SEWAGE DISPOSAL SYSTEM

MARYLAND STATE DEPARTMENT OF HEALTH

P 44610
A Repair

SUBDIVISION Dickey Farms ROAD ¹¹⁵⁵1041 Day Road LOT 27

44610

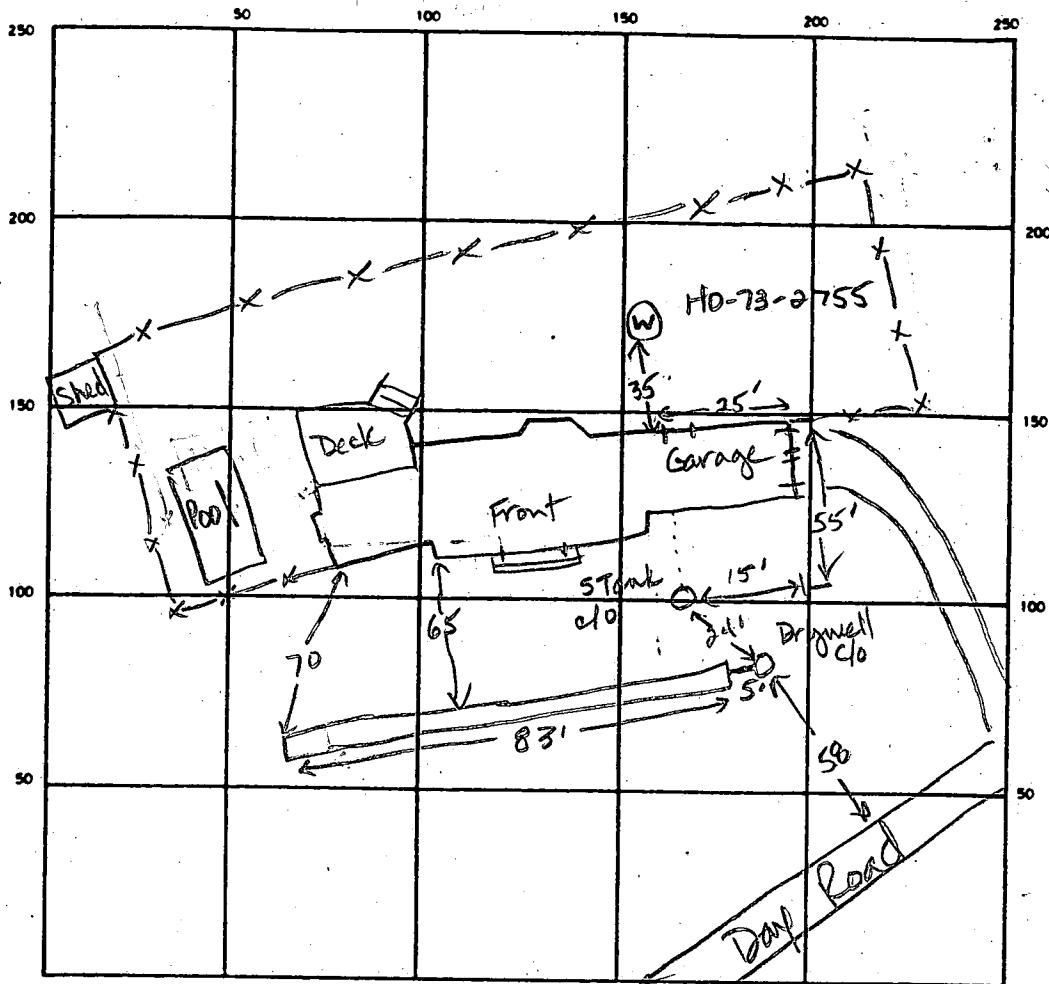
REPAIR - CALL FOR INSPECTION WHEN GROUND IS OPENED UP SO SANITARIAN CAN RECOMMEND REPAIR.

X=10 min, 210 sqft/blrm, Inlet=3.0ft. Bottom=8.0ft. 5ft stone. Use existing drywell (384 sqft area)

REMARKS 5-26-89 Existing drywell and tank ok. OK to cover all work.
Oversized system JEN

PLAT PLAN

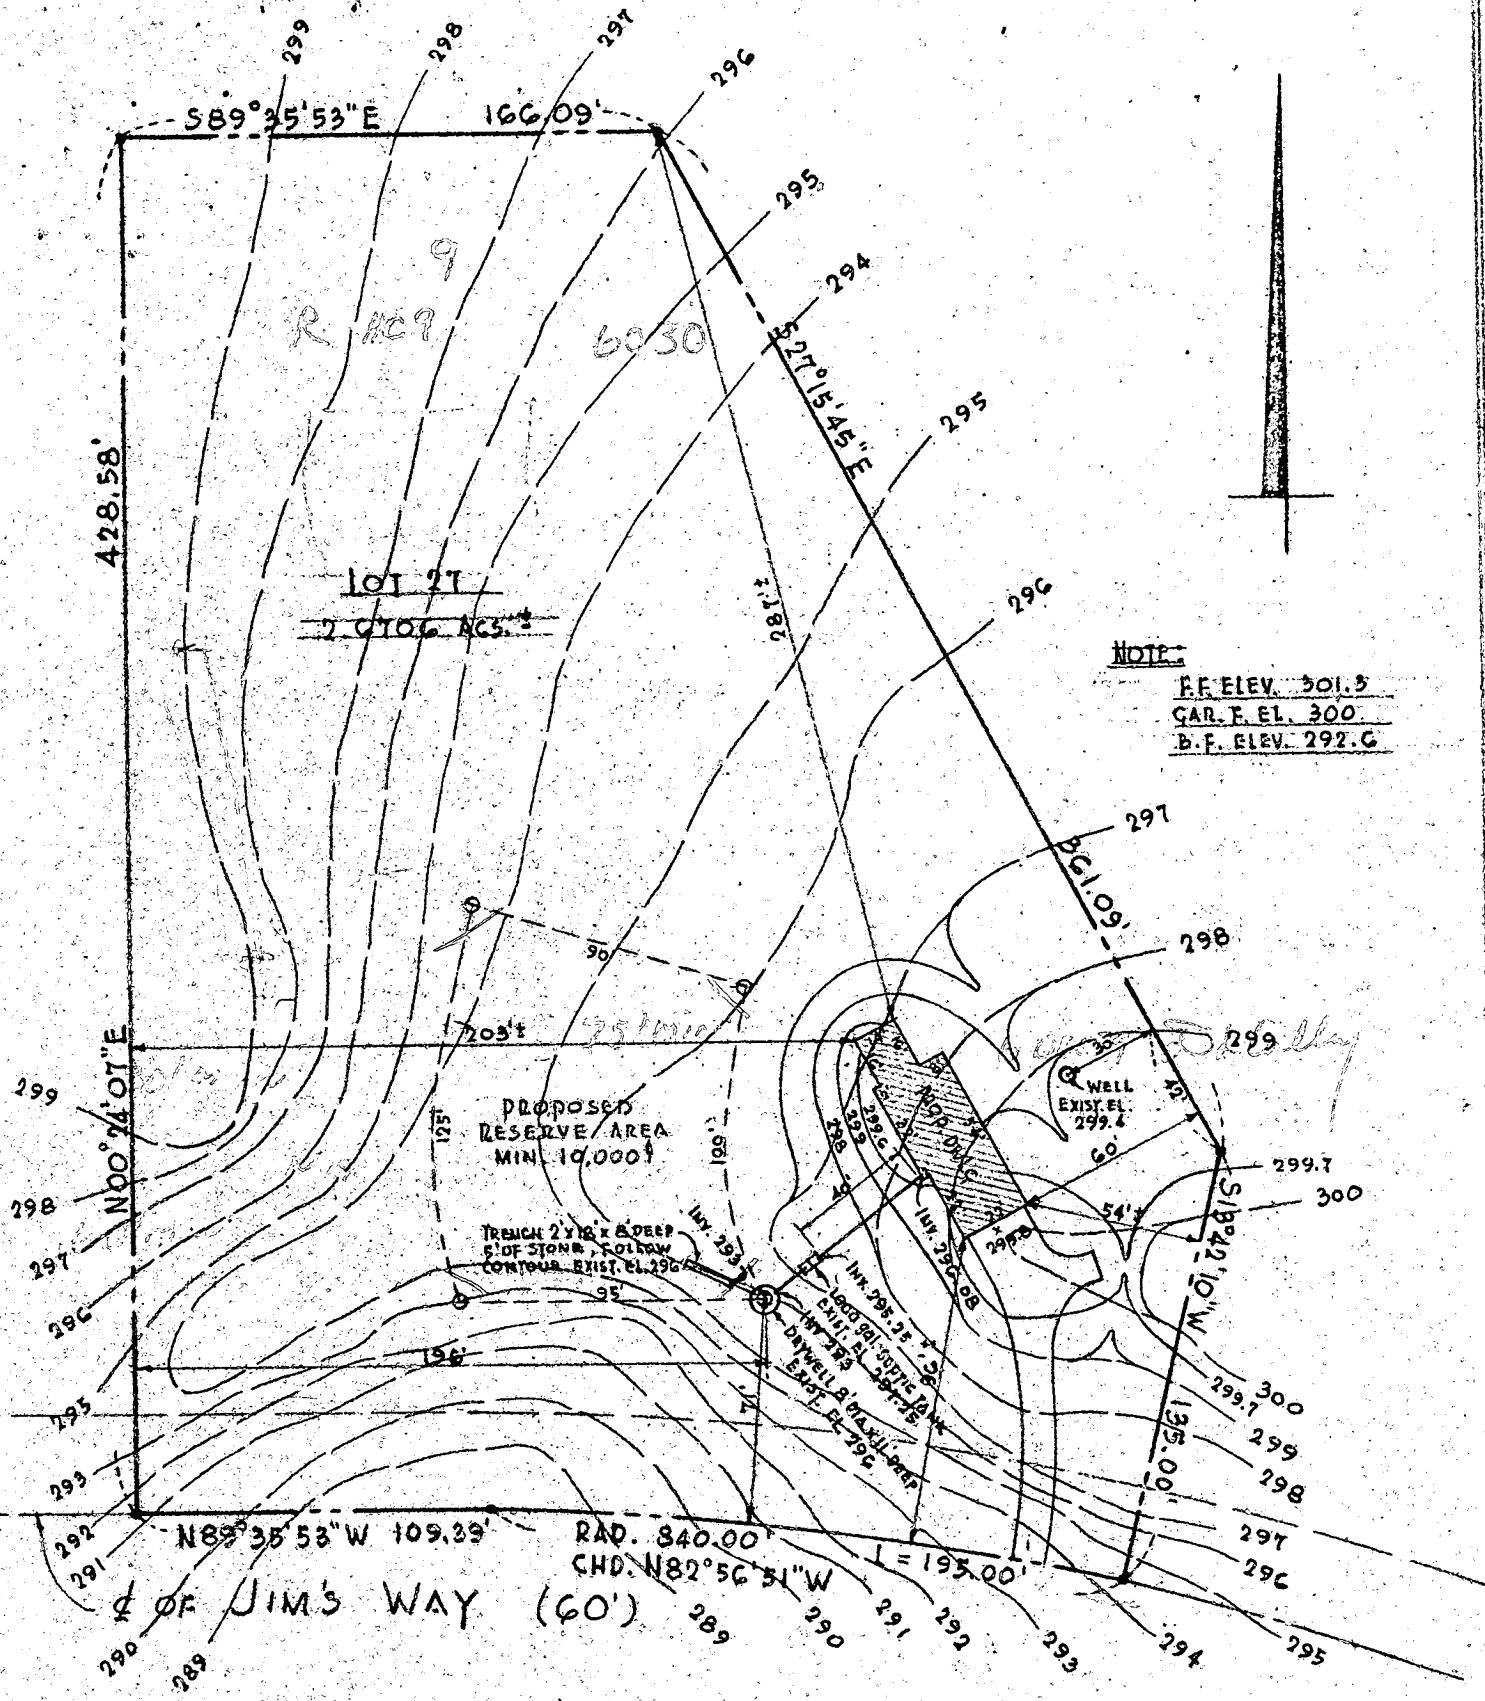
REMARKS 3/11/80 - Not ready (10:30) JS

3/11/80 - (12:45) OK to comm. all work JS

12/10/79 PLANS OK. RH

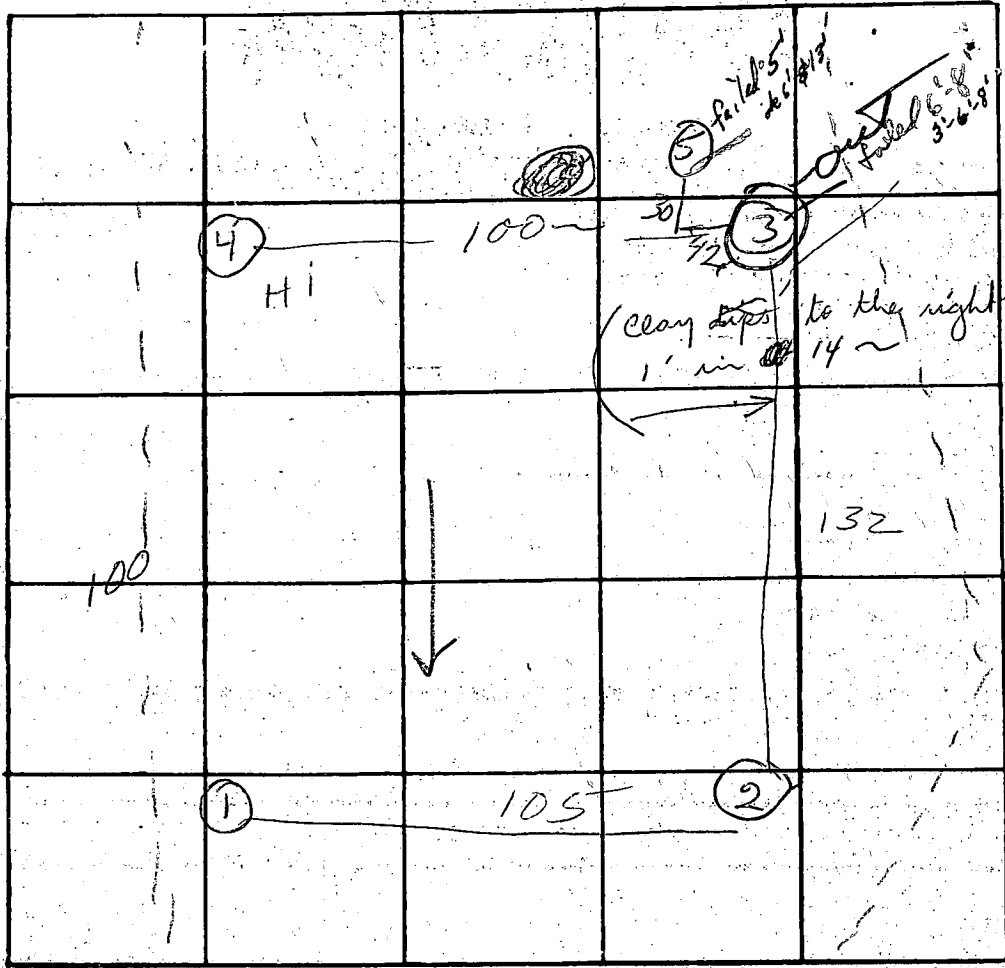
Recommend system in #4 with insert @ 4-5 ft soil starts at 6 ~
